WILLIAMSON COUNTY, TEXAS

CHANGE ORDER NUMBER: 2

Project: 1907-333

Roadway: O'Connor Traffic Signals

O'CONNOR DR AT
GREAT OAKS DR
PROPOSED SIGNAL LAYOUT

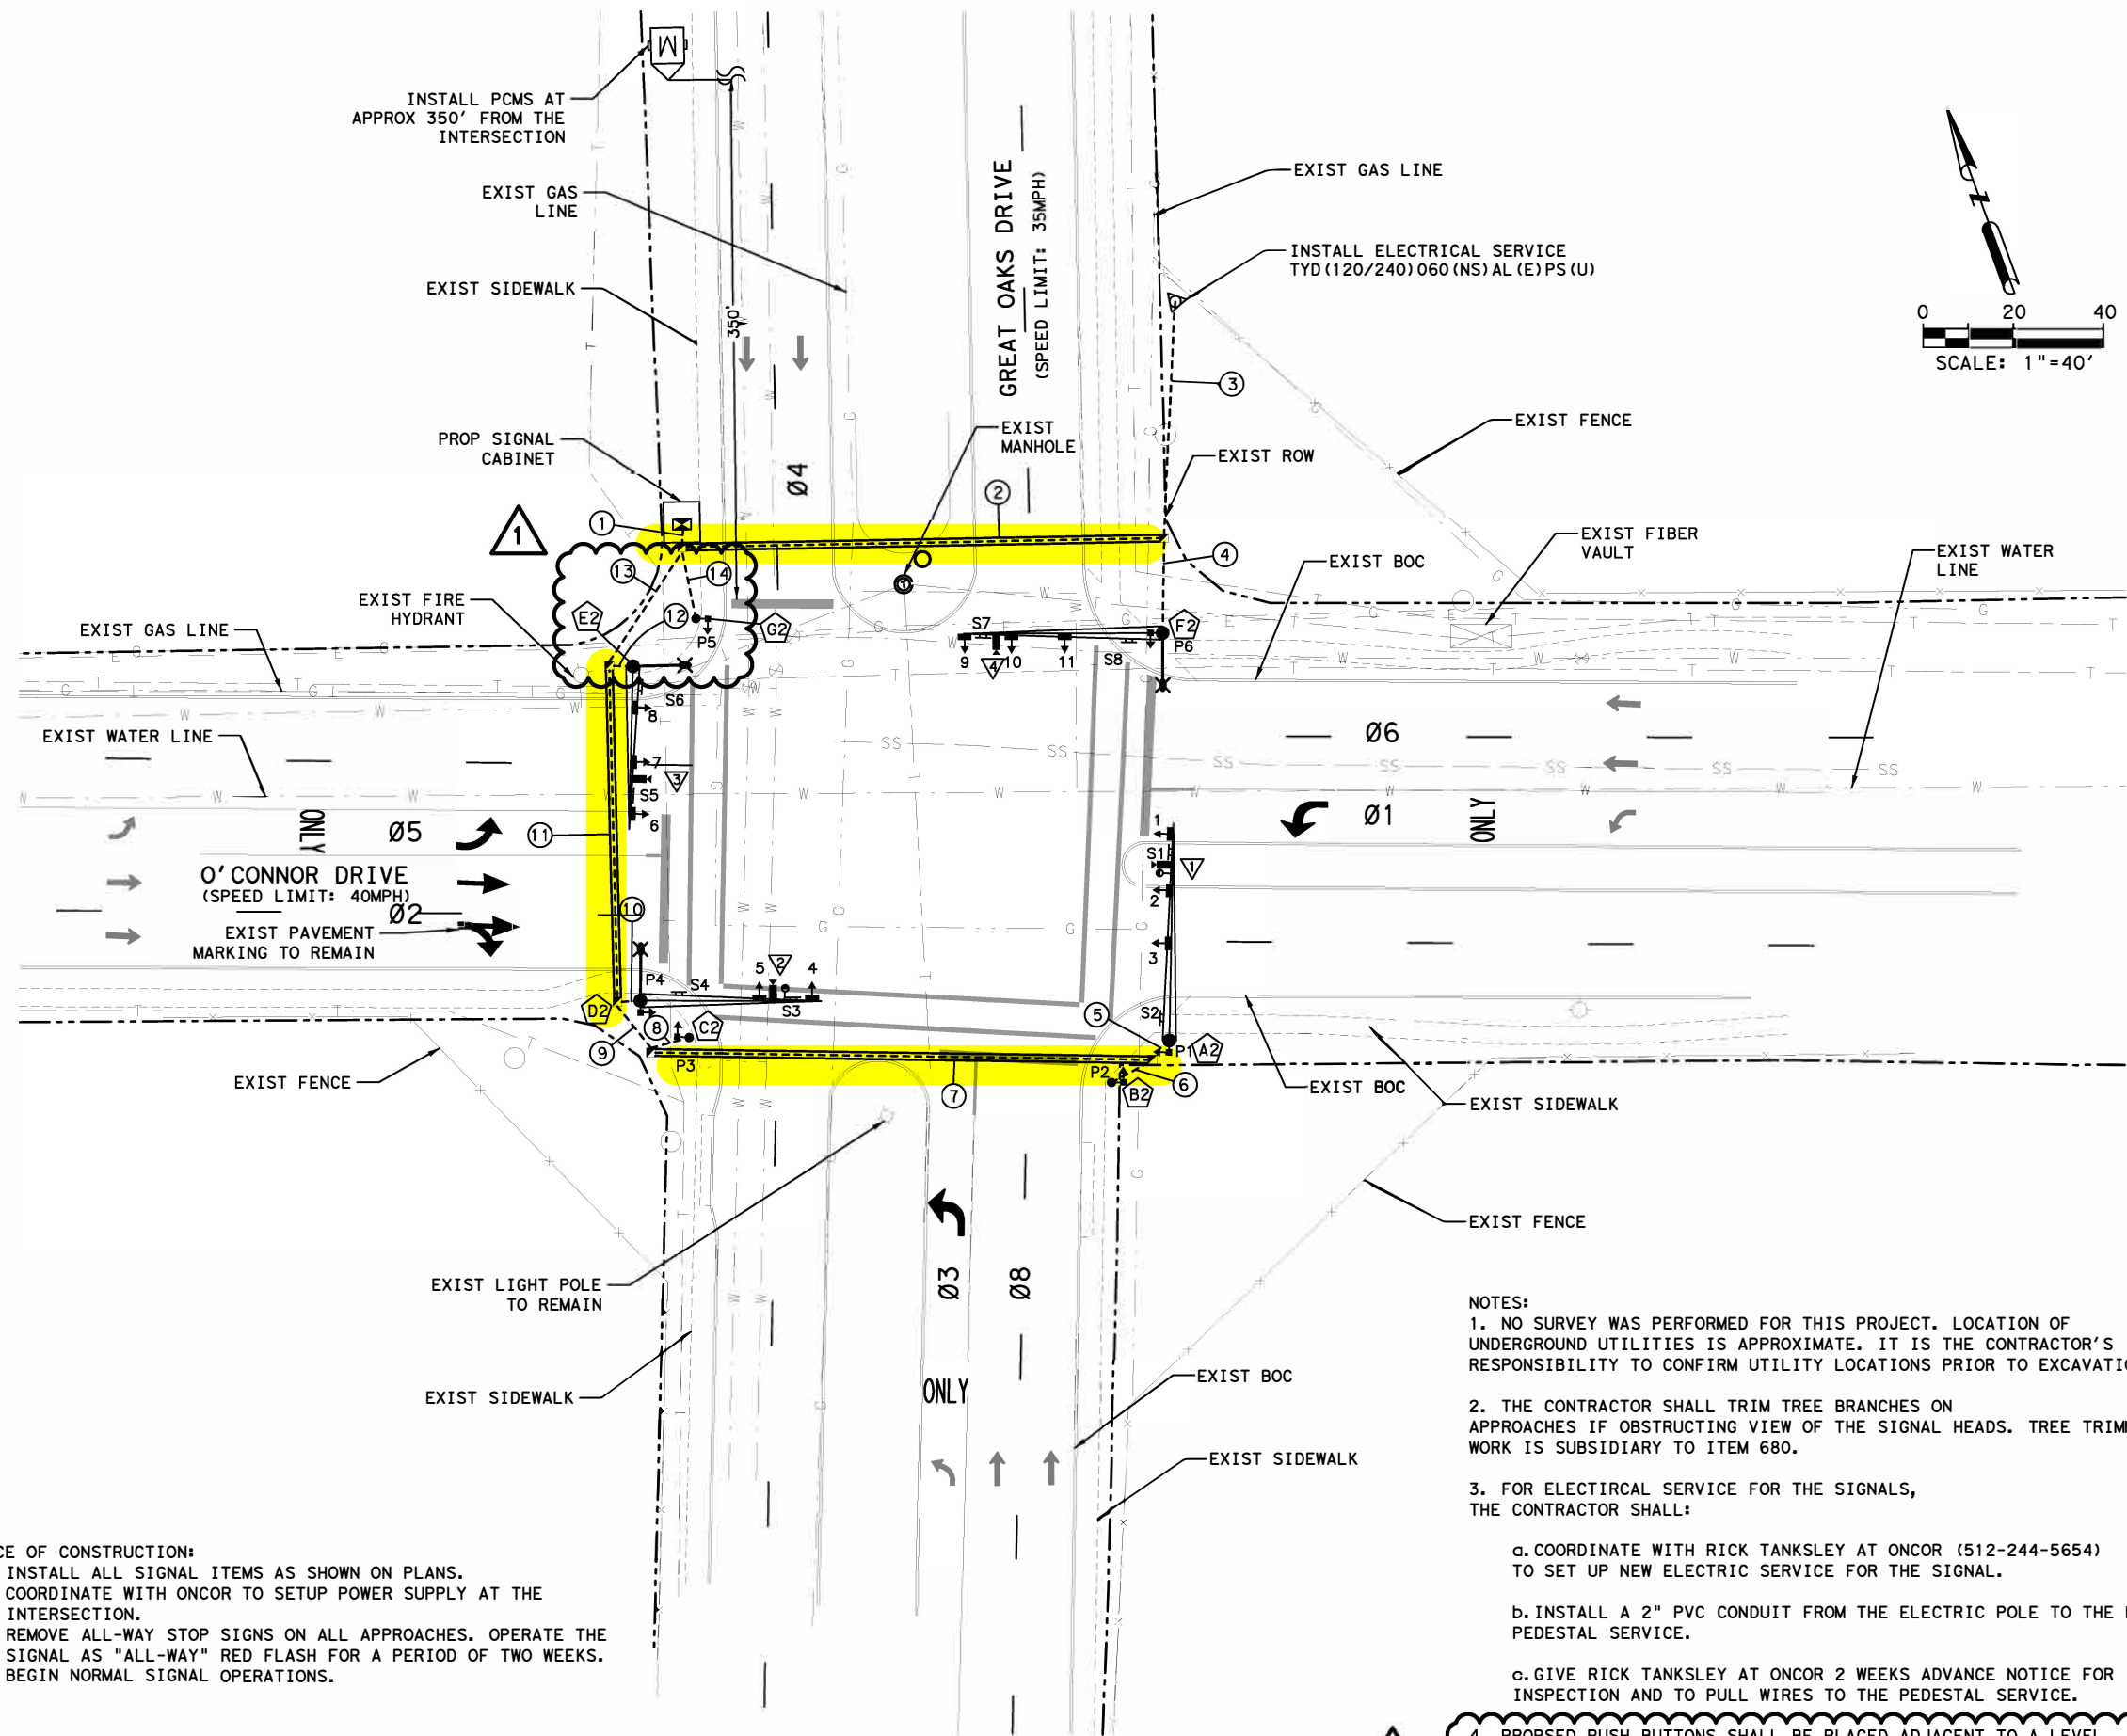
FIELD CHANGE: OPEN TRENCH CONDUIT - ROADWAY (O'Connor Dr @ Great Oaks Dr)

OPEN TRENCH - GREAT OAKS DR

2E: Differing Site Conditions (unforeseeable). Miscellaneous difference in site conditions (unforeseeable). This Change Order changes the method of construction from directional boring to open trenching for the installation of conduits under the existing roadway for the signals at the intersection of O'Connor Drive and Great Oaks Drive. To accommodate the open cut trench method, the designer changed the conduit from 2 - 3 inch and 1 - 2 inch conduits to 4 - 2 inch conduits. This Change Order also adds a new Force Account item to pay for off-duty police officers and vehicles for traffic control during open trenching operations at the Great Oaks and Morgan Hill intersections.

This Change Order changes method of construction from directional boring to open trenching for the installation of conduits under the existing roadway at the intersection of O'Connor Drive and Great Oaks Drive. This change in the method of construction was necessary due to the location of existing utilities within the right of way and in the roadway. To accommodate the open trenching method, the designer changed the conduit from 2 – 3 inch and 1 – 2 inch conduits to 4 – 2 inch conduits. The conduit run equals approximately 300 feet and this change order adds an additional 2 inch run to the project, totally 1,200 linear feet.
